DEVELOPMENT APPLICATION ASSESSMENT REPORT

| Application Number: DA2024/1028 | Application Number: | DA2024/1028 |

| Responsible Officer: | Lachlan Rose |
|------------------------------------|--|
| Land to be developed (Address): | Lot 39 DP 5659, 30 Surf Road NORTH CURL CURL NSW 2099 |
| Proposed Development: | Alterations and additions to a dwelling house |

Figure 1: Front Setback Non-compliance.

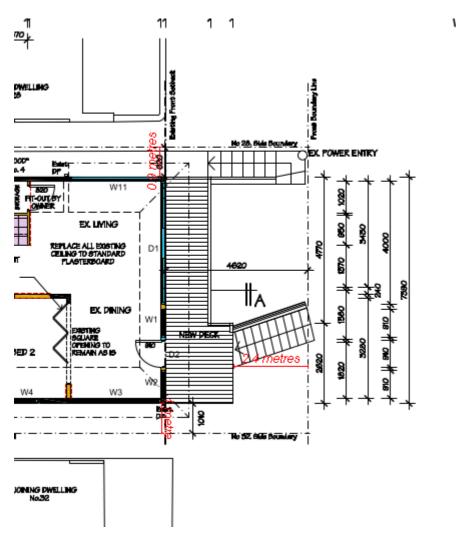
Clause B7 Front Boundary Setbacks requires that built structures on the subject site are setback a minimum 6.5m from the front boundary.

The front setback to the deck area is 2.4m, resulting a variation to the requirement of Clause B7 Front Boundary Setbacks of 63%. The setback to the dwelling house is 4.6m, resulting a variation to the

requirement of Clause B7 Front Boundary Setbacks of 29%. See figure below:

It should be noted that the proposed works do not result in an increase in the breach of the front setback non-compliance. Specifically, the development includes the demolition and replacement of the two (2) existing stairs to the front setback and the timber posts/ deck to the existing deck. Therefore, there are no new proposed works to the front setback, other than the replacement of the existing stairs and deck.

As the existing non-compliant setback to Surf Road remains unchanged, a merit assessment is not required in this circumstance.
